HISTORIC AND DESIGN REVIEW COMMISSION

HDRC CASE NO: 2021-026
COMMON NAME: Unaddressed lot to the immediate south of 334 Burleson, on N Mesquite
ADDRESS: 334 BURLESON ST
LEGAL DESCRIPTION: NCB 519 BLK 24 LOT E 42 FT OF N 134.09 FT OF 8
ZONING: IDZ-1, H
CITY COUNCIL DIST.: 2
DISTRICT: Dignowity Hill Historic District
APPLICANT: cesar sosa/5 ELEMENTS INTERNATIONAL LLC
OWNER: Ruben Lara/5 ELEMENTS INTERNATIONAL LLC
TYPE OF WORK: Construction of two, 2-story residential structures
APPLICATION RECEIVED: February 04, 2021
60-DAY REVIEW: Not applicable due to City Council Emergency Orders
CASE MANAGER: Edward Hall

Historic and Design Review Commission
Design Review Committee Report

PROJECT NO. S-363
CONSTRUCTION DOCUMENTS
10 SEPTEMBER 2020

1 BUILDING SECTION
SCALE: 1/4" = 1'-0"

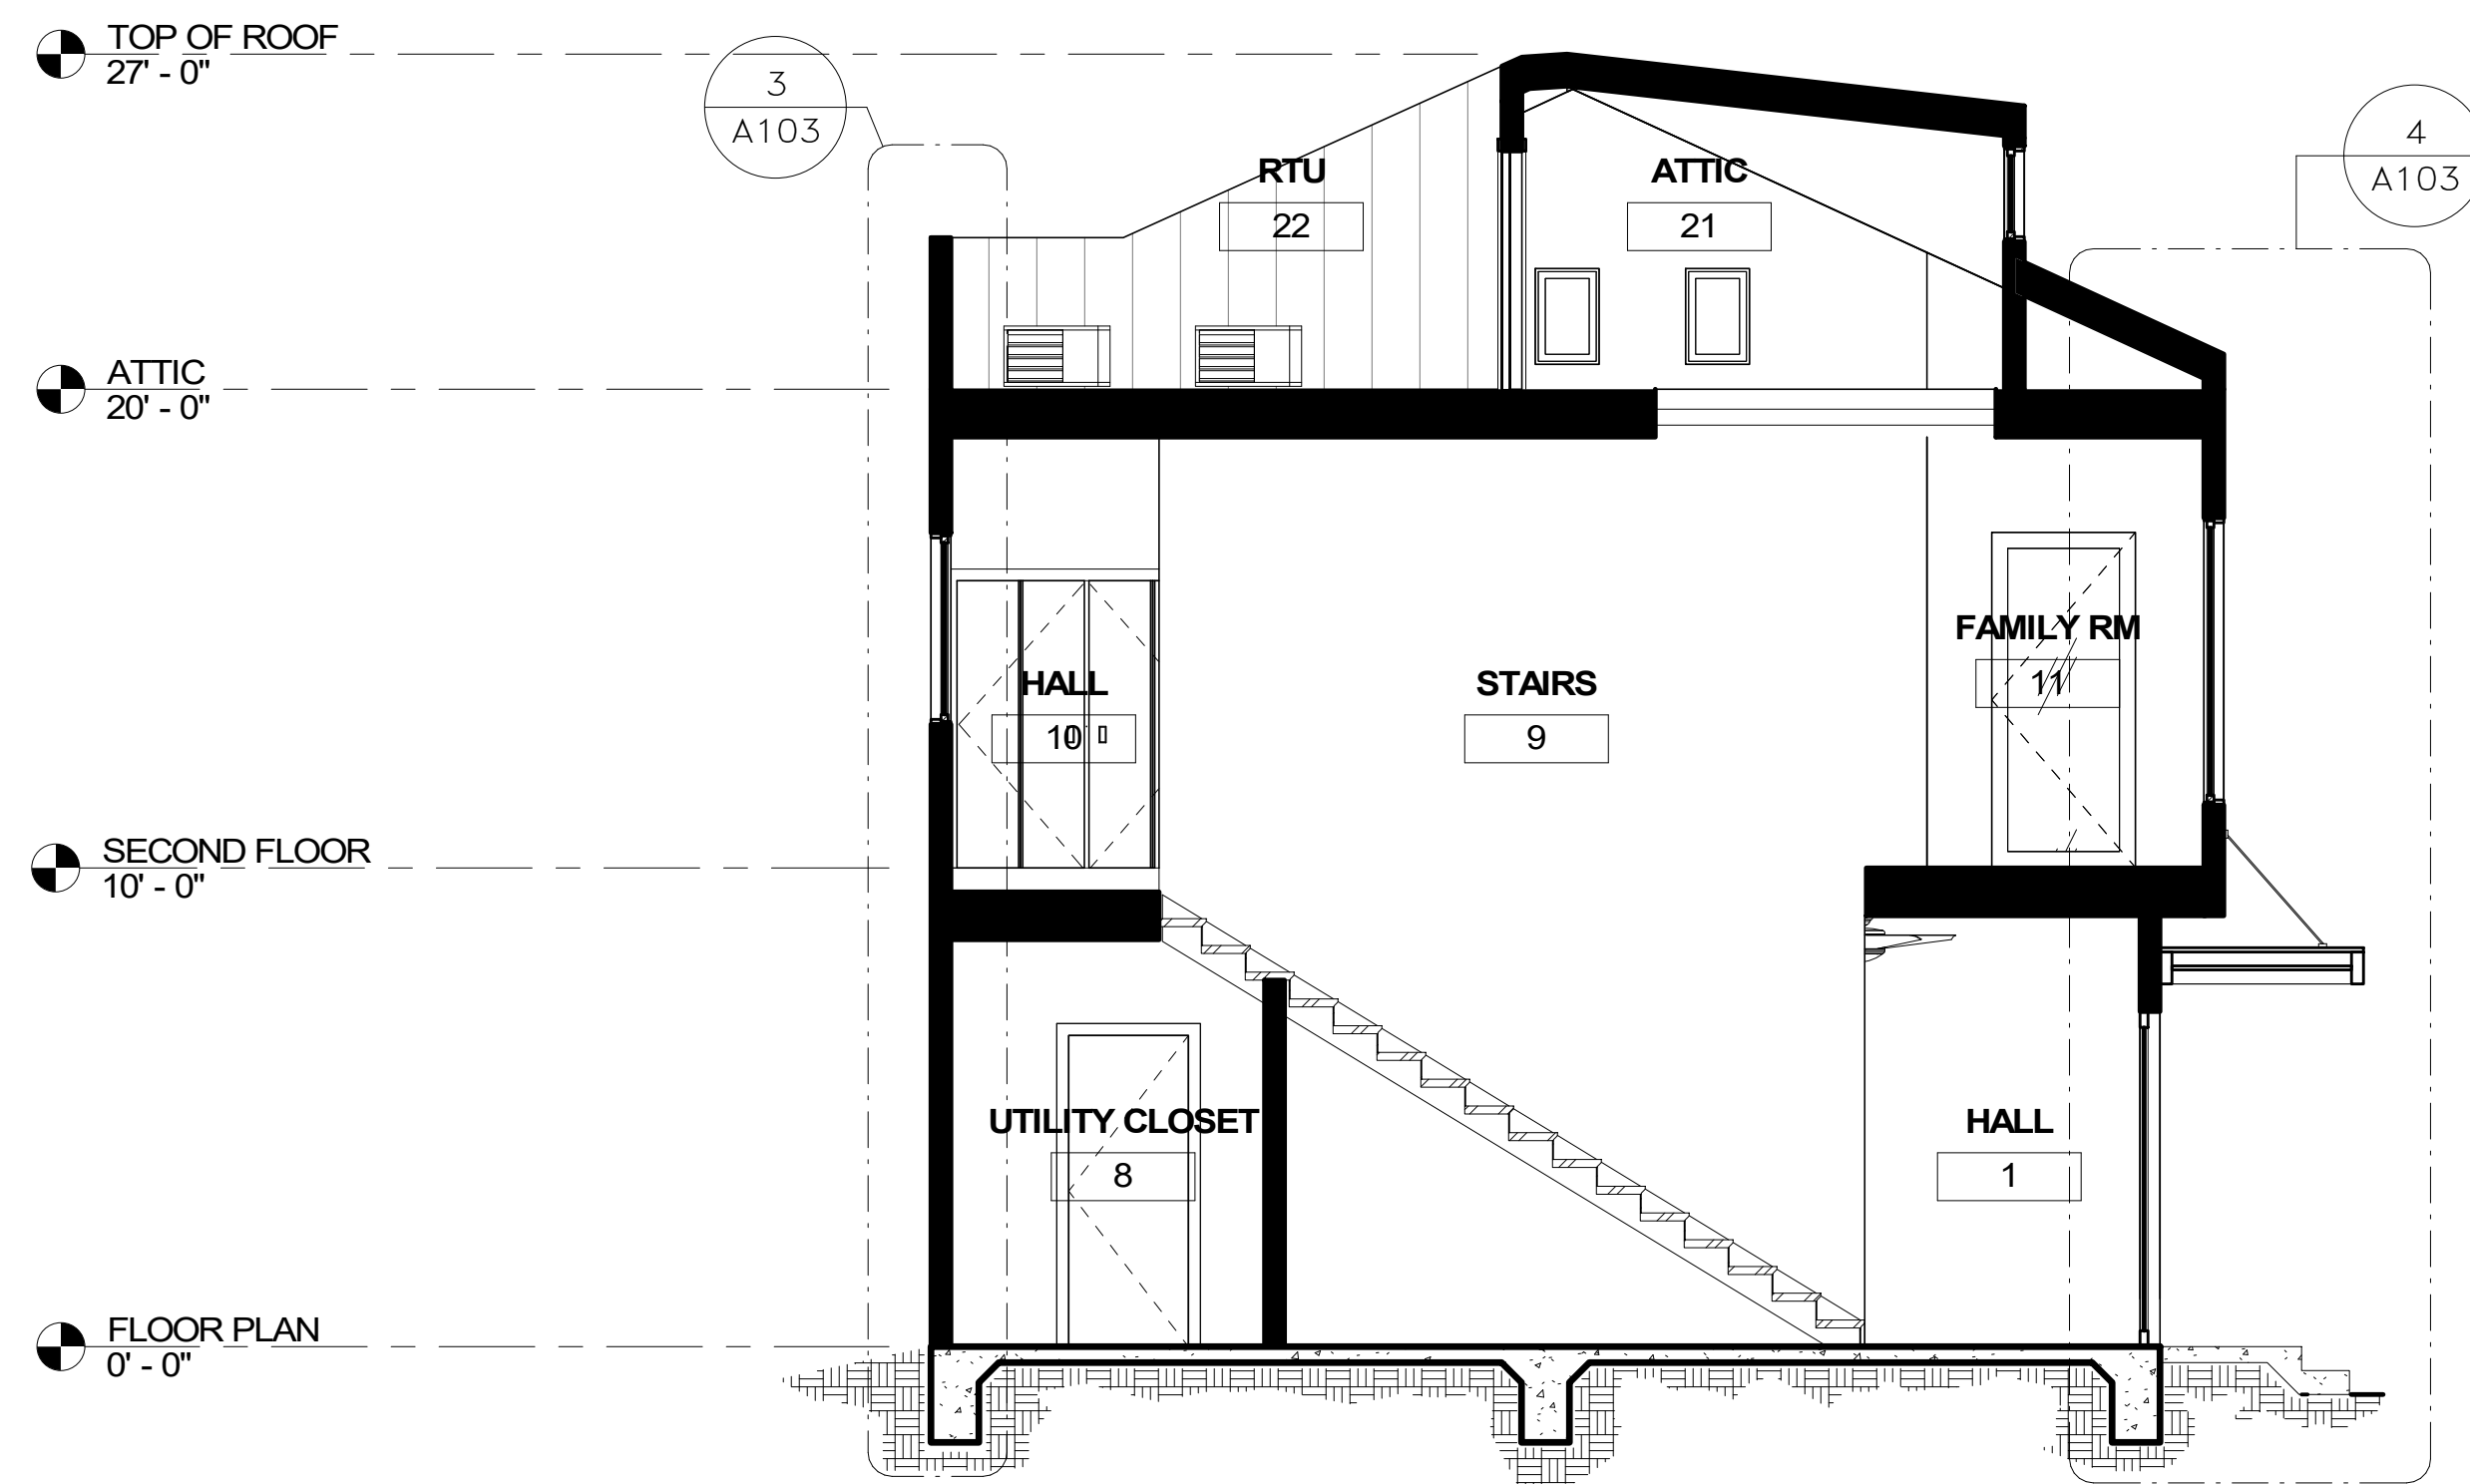
- 1b. **SCALE & MASS** – Per the Guidelines for New Construction 2.A.i., a height and massing similar to historic structures in the vicinity of the proposed new construction should be used. In residential districts, the height and scale of new construction should not exceed that of the majority of historic buildings by more than one-story. As noted in finding b, this block of Burleson features all one story structures. Staff does not find the proposed height to be consistent with the Guidelines.

- 1c. **ENTRANCES** – According to the Guidelines for New Construction 1.B.i., primary building entrances should be oriented towards the primary street. The applicant has not proposed design elements that present a primary building entrance. Staff finds that architectural elements that are found historically within the district that relate to building entrances should be incorporated into the design, such as porches and porch massing.

- 1d. **FOUNDATION & FLOOR HEIGHTS** – Per the Guidelines for New Construction 2.A.iii., applicants should align foundation and floor-to-floor heights within one foot of floor-to-floor heights on adjacent historic structures. The applicant has proposed to construct the structure on grade with no visible foundation height. This is not consistent with the Guidelines.

- 1e. **ROOF FORMS** – The applicant has proposed a primary roof form to feature a front facing gabled roof. The proposed roof features two dormer elements, one of which features a void that allows for a rooftop seating element. Generally, staff finds the proposed roof forms to be atypical of those found historically within the district and inconsistent with the Guidelines.

- 1f. **WINDOW & DOOR OPENINGS** – Per the Guidelines for New Construction 2.C.i., window and door openings with similar proportions of wall to window space as typical with nearby historic facades should be incorporated into new construction. The applicant has proposed window and door openings that are contemporary in profile and size. Staff finds that the proposed window and door openings are not consistent with the Guidelines and should be modified.

- 1j. **ARCHITECTURAL DETAILS** – The applicant has proposed new construction that features contemporary forms. Generally, the proposed massing, lack of porch massing, window and door openings, materials and façade detailing are not consistent with the Guidelines.

- ii. That the applicant reduce the proposed massing to be consistent with the Guidelines, as noted in finding 1b.
 - iii. That the applicant incorporate both entrance massing and architectural entrance elements as noted in finding 1c.

- iv. That the applicant incorporate foundation and floor heights that are consistent with the Guidelines, as noted in finding 1d.
 - v. That the applicant incorporate roof forms that are consistent with the Guidelines as noted in finding 1e.

- vi. That the applicant incorporate window and door openings that are consistent with the Guidelines as noted in finding 1f.
 - vii. That the applicant incorporate materials and windows materials that are consistent with the Guidelines as noted in findings 1h and 1i. Wood or aluminum clad wood windows should be installed as noted in finding 1i and in the applicable citations.
